Iditarod Dog Sledding Historic District Meeting

Wednesday, January 11, 2012

Iditarod Dog Sledding Historic District (IDSHD) Workshop Workshop Summary and Implementation Plan Comment Resolution Summary

Exhibit 1: Historic Iditarod Trail crossing design before and after the IDSHD Workshops¹

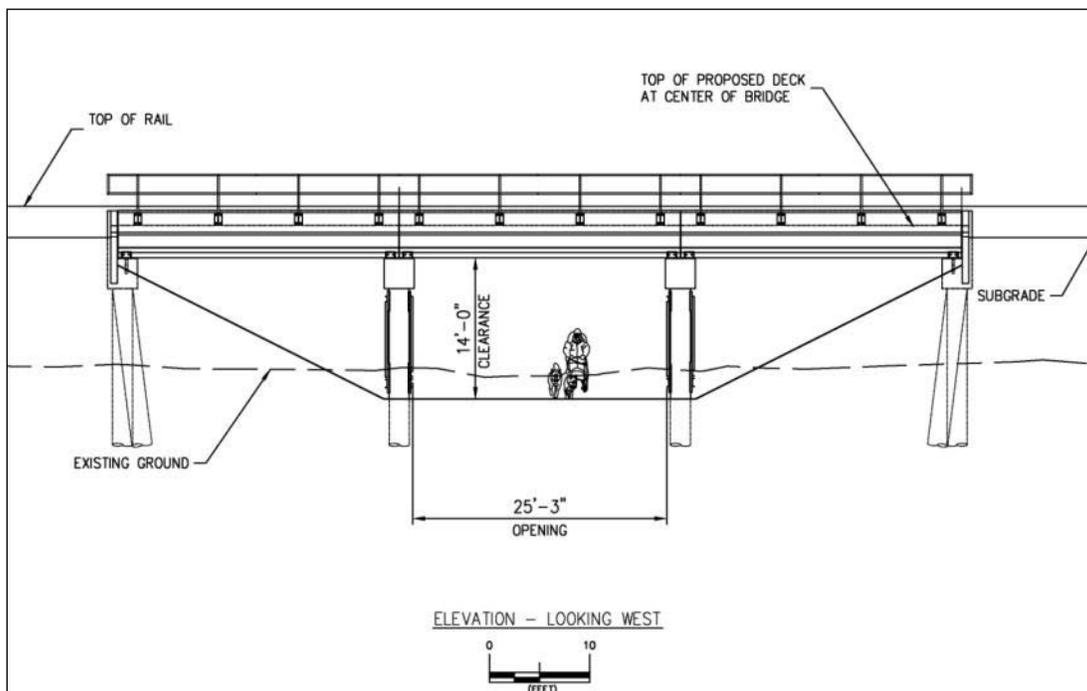
1. *The height (vertical clearance) of crossings needs to be increased to more than 12' to account for snow depth, accommodate equipment for grooming of trails, and enhance safety. The existing clearance is as low as 10' for some crossings.*

Proposed Resolution: The Project Team has redesigned bridges/crossings with the vertical clearance increased to a minimum of 14', whenever possible. Table 1 summarizes previously and currently proposed trail and road crossings for the PMRE project. Vertical clearances will range from 12' to over 18'. Only two crossing structures, located south of the Agricultural District, will have a vertical clearance less than 14'. One of these crossings (Crossing 14), which will be a three-span bridge providing between approximately 12' vertical by approximately 25' horizontal clearance, is adjacent to the Baker Farm Road at-grade crossing (Crossing 15) and provides an alternative crossing option in the vicinity (Table 1). The other crossing is the Figure 8 Lake Loop trailhead crossing (Crossing 16), which will be accommodated by a 19'-6" plate pipe, providing between 10' and 14' vertical by 16' horizontal clearance (Table 1). A bridge crossing in this location is not practicable due to the poor soil conditions and high-railroad embankment through the area. Alternative access for over-height vehicles is provided by the access road from Lu Young Lane, south of the Bulk Material Bi-modal Facility (BMBF).

Increasing the vertical clearance under a bridge also increases the footprint of the embankment approaching the bridge, which often increases wetlands impacts. The design team has tried to strike a reasonable balance between the needs of trail users and our obligations to minimize impact to wetlands under Federal law. Exhibit 1 shows a comparison of the previously proposed Historic Iditarod Trail crossing and the currently proposed crossing that has been refined based on comments from trail users. As illustrated in this example, the vertical clearance was increased, based on comments from workshop participants, from approximately 12' to 14'.

Exhibit 2: Approach example

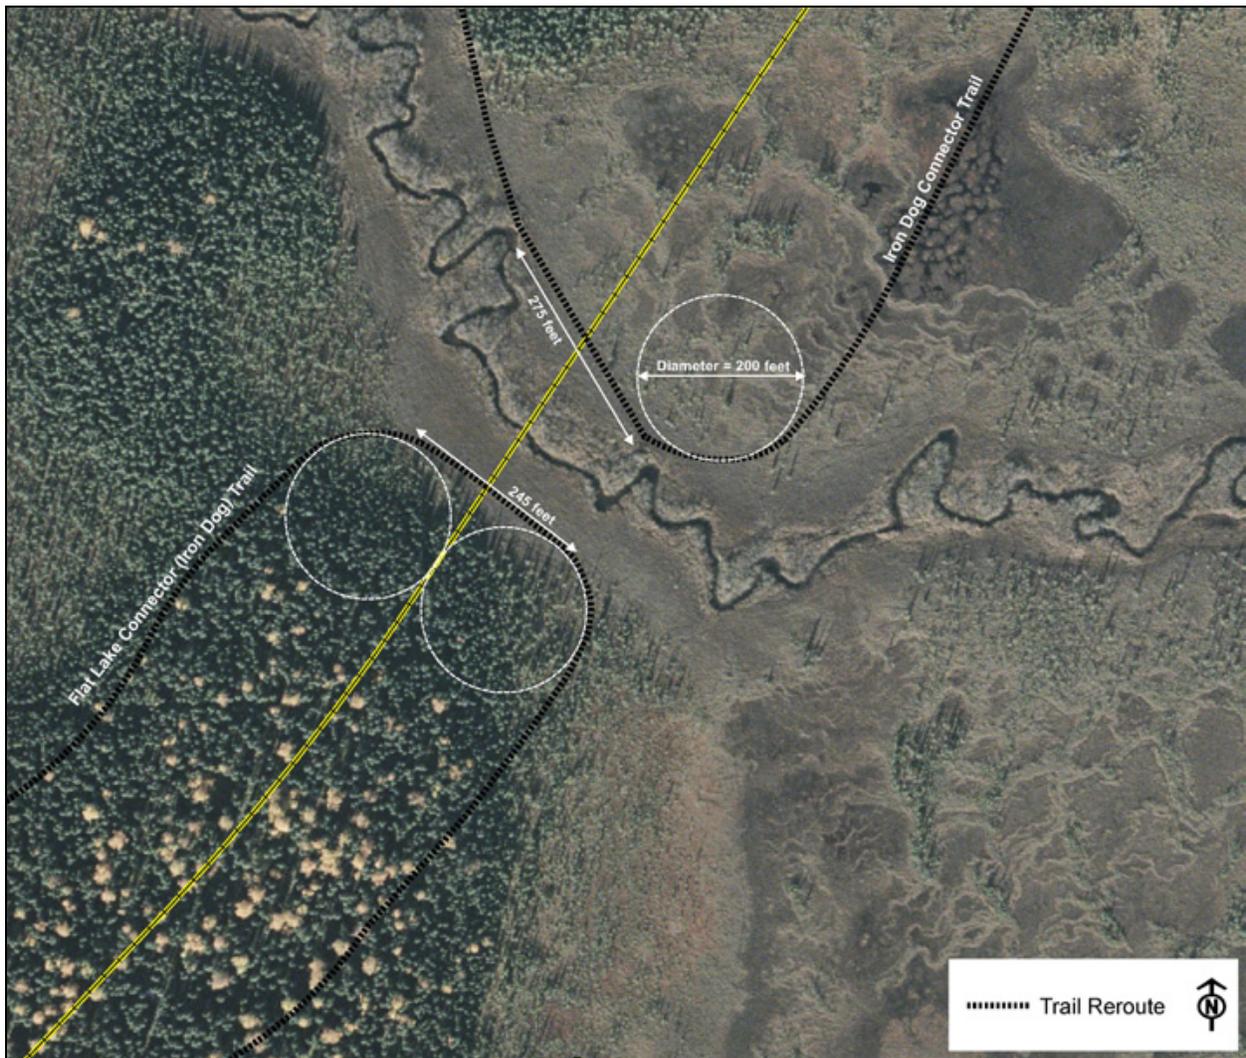
2. The length of a sled dog team with 16 to 20 dogs (approximately 85') needs to be considered during design of trail approaches to crossings to ensure curves are not too tight. (This comment was made in reference to the rerouted trails, specifically Crossing H 6.3 [Project Crossing 5]).

Proposed Resolution: The Project Team has been working with Sustainable Design Group to develop standards for sight distance needs and crossing approaches that will accommodate a 100' long vehicle/dog team, which requires a minimum 60' turn radius. The design standard for trail approaches to crossings includes gentle curves with turn radii between 75' and 90'. This turn radius will allow for a 100' long dog team to turn and safely pass through the structure while allowing adequate line of sight for trail users prior to passage (Exhibit 2).

Exhibit 3: Crossing 5 (H 6.3) profile view

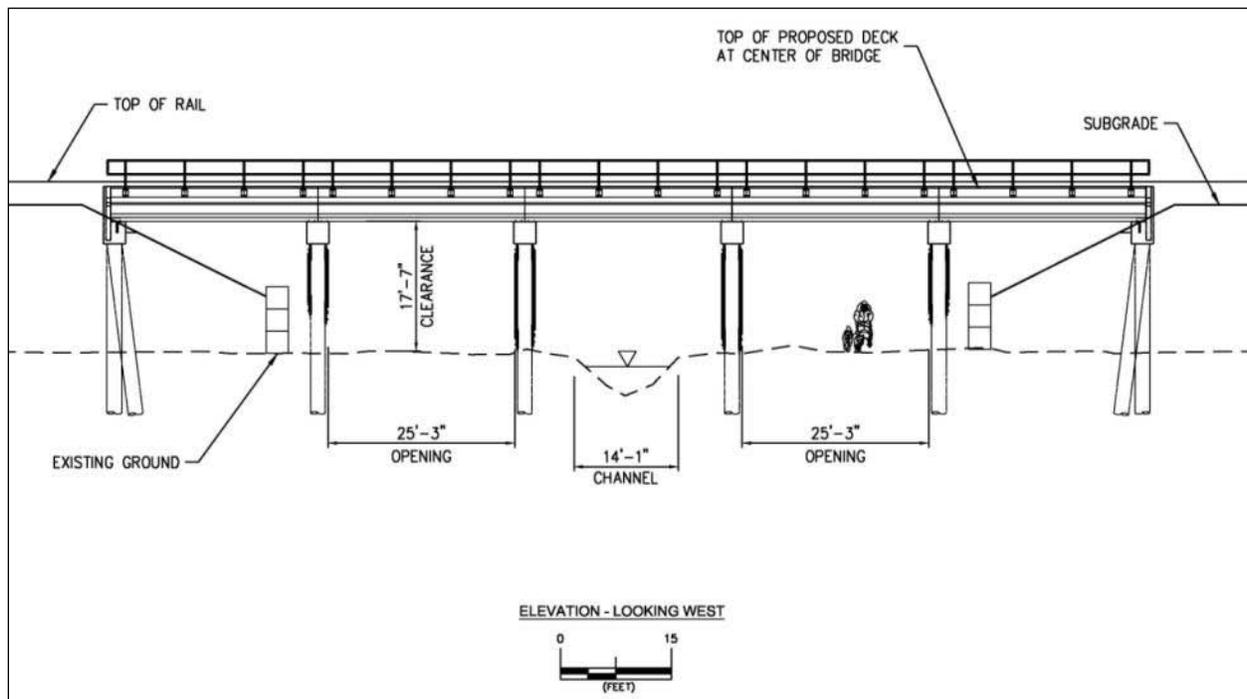
10. *Incorporate safety considerations into design for the Houston 6.3 crossing (Crossing 5). Design should account for increased traffic caused by funneling multiple trails into a single crossing and should include wider/higher openings under the bridge, a wider turn radius for the reroutes approaching the crossing location, and a good line of sight approaching and extending under the crossing.*

Proposed Resolution: The original crossing design at this location was to construct a three-span bridge with 12'-7.5" of vertical clearance, two spans with 14' horizontal clearance, and a center span with over 25' of horizontal clearance. The design carried forward to the MSB Trail User Open House (10/27/11) where MSB presented a five-span crossing structure with increased vertical clearance but similar horizontal clearances. Concerns of trail users attending the MSB Trail User Open House (10/27/11) were addressed by upgrading the crossing structure to provide additional horizontal clearances. The improved structure will accommodate a trail on both the north and south side of the creek, each with 25' horizontal clearance to accommodate multiple users and grooming equipment with a vertical clearance of more than 17'. Exhibit 3 (see Comment 8 above) shows the most recent proposed design for Crossing 5.

Exhibit 4: Proposed Iron Dog Connector Trail Reroute and Crossing (Crossing 5)

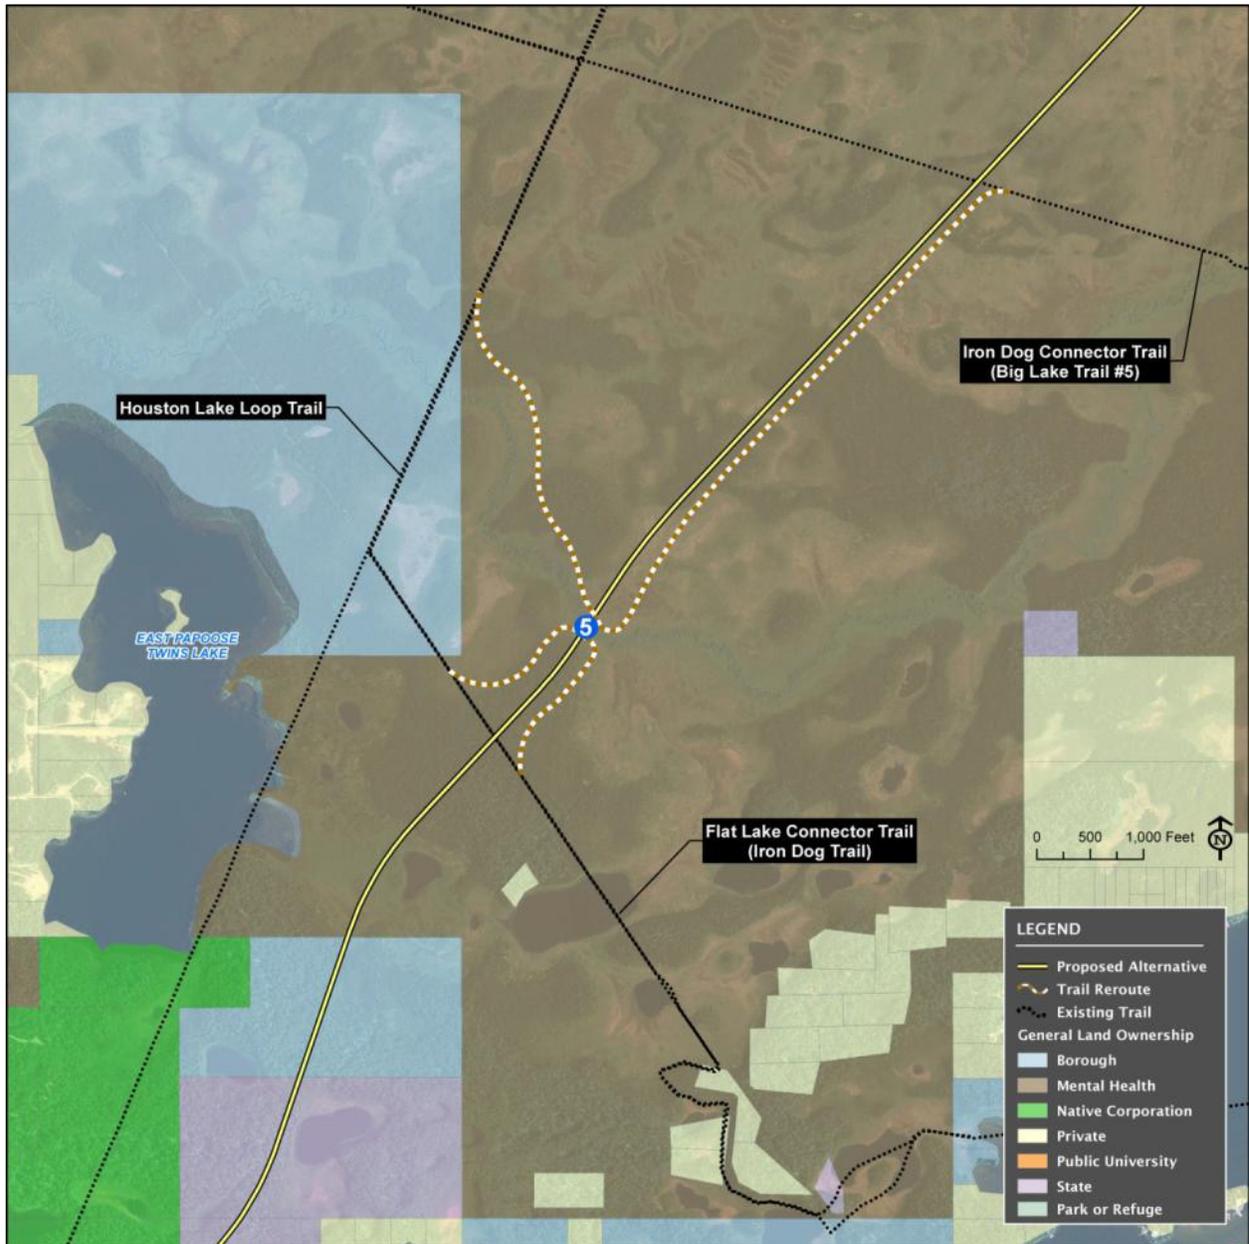
8. Provide a crossing for the Iron Dog Connector Trail (Big Lake Trail #5 in MSB Trails Plan)

Proposed Resolution: The Iron Dog Connector Trail is identified in MSB trail plans as a winter use only trail as it traverses portions of wetlands and lakes in the project area. Due to safety concerns, wetland and regulatory concerns, tree cover, and topography (see Comment 5), a crossing is not a good option at its current location. Therefore, the Project Team proposes to reroute the trail to the northern usable span of a five-span bridge with approximately 25' of horizontal clearance and 17' of vertical clearance (Crossing 5; Exhibit 3). The rerouted trail will be reconnected with the Houston Lake Loop Trail north of the rail embankment (see Exhibit 4).

Exhibit 5: Possible Iditarod Race Trail Reroute and Crossings

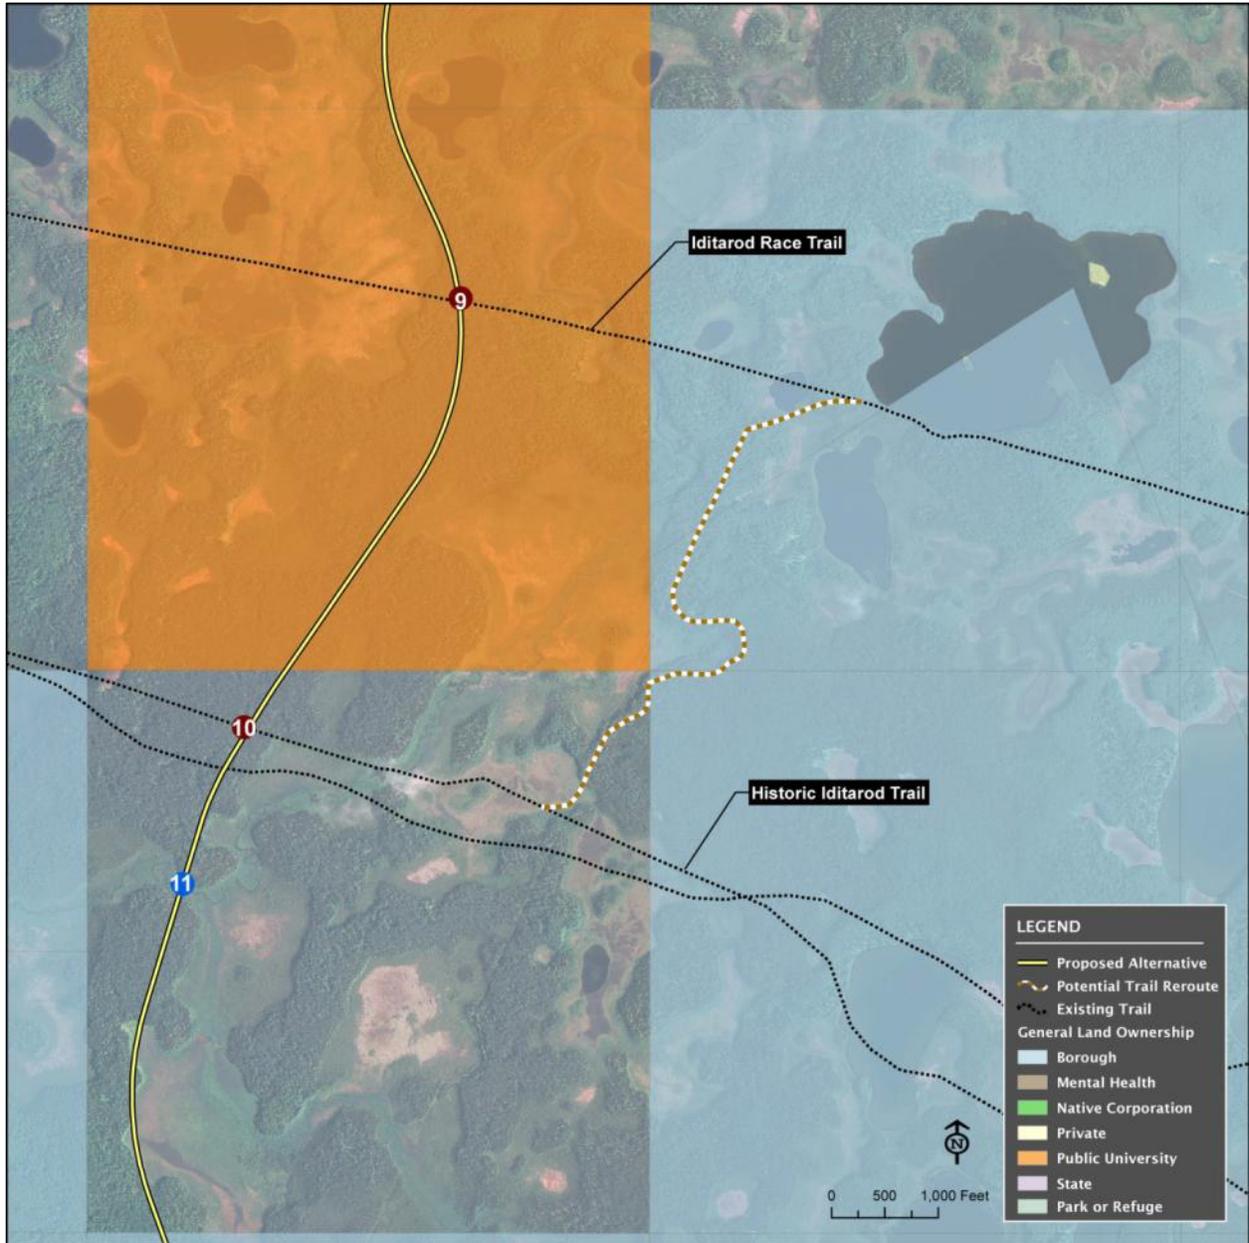
11. Provide a crossing for the Iditarod Race Trail and obtain an easement from the University of Alaska for this trail should one not currently exist. This trail has reportedly hosted 20 Iditarod races and is used more frequently/regularly than the Historic Iditarod Trail. A separated grade crossing (bridge) is preferred, but if a bridge is not possible, an at-grade crossing would be better than no crossing at all.

Proposed Resolution: Approaches to a crossing for the Iditarod Race Trail would be on University of Alaska land. The MSB is working with UA to secure an easement at this location if no easement currently exists. The crossing (Crossing 9) would be a typical three-span bridge with a minimum 14' vertical clearance, and approximately 25' of horizontal clearance in the center span (see Exhibit 1 as an example and Table 1). Approach improvements would include widening the trail in the vicinity of the crossing.

If negotiations with UA to secure an easement are unsuccessful, a crossing would not be provided for the Iditarod Race Trail as it would encourage trespassing on UA property. The Race Trail would be rerouted to the Historic Iditarod Trail, which would be upgraded/improved to accommodate the potential increase in users (Exhibit 5; see Comment 12).

Exhibit 6: Connectivity between Crossings 7 and 10

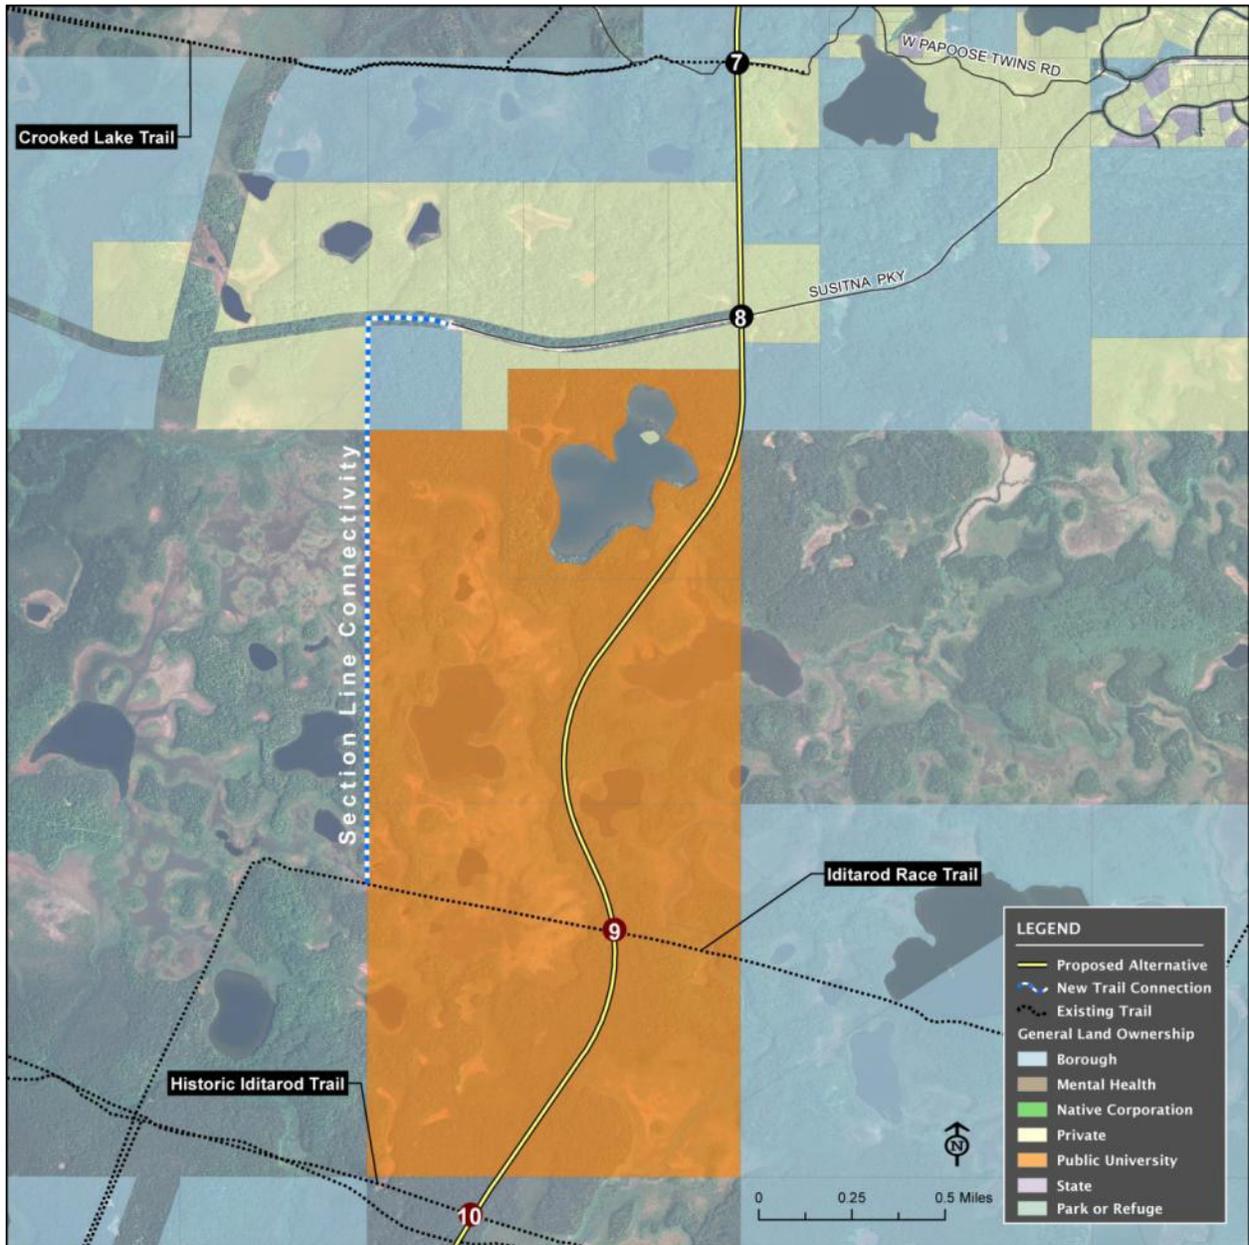
14. Provide north-south trail along one or both sides of the proposed ROW to help maintain connectivity. Even if there is not a dedicated trail, people would still likely travel along this area.

Proposed Resolution: Trail reroutes, enhanced crossing structures and strategies to maintain connectivity in a safe manner are all measures the Project Team has and continues to work toward as this project moves forward. The proposed railroad alignment is orientated predominately north-south, and therefore, the Project Team believes that the project primarily affects east-west connectivity, not north-south connectivity. We have been working diligently with local trails groups/users, regulatory agencies and other interested parties to maintain east-west connectivity.

Most of the existing trails identified both in the Final Environmental Impact Statement (FEIS) and trails workshops that provide north-south movement will remain intact. The Project Team believes that the existing trail system west of the proposed rail corridor provides a north-south corridor (Figure 3 of Attachment 1). However, one area of concern for north-south connectivity has been identified between Crossings 7 and 10 (Exhibit 6). This area demonstrates the biggest gap in connectivity and is owned primarily by UA. The Project Team has developed an alternative corridor for north-south travel in this area that may work for trail users and property owners (see Exhibit 6).
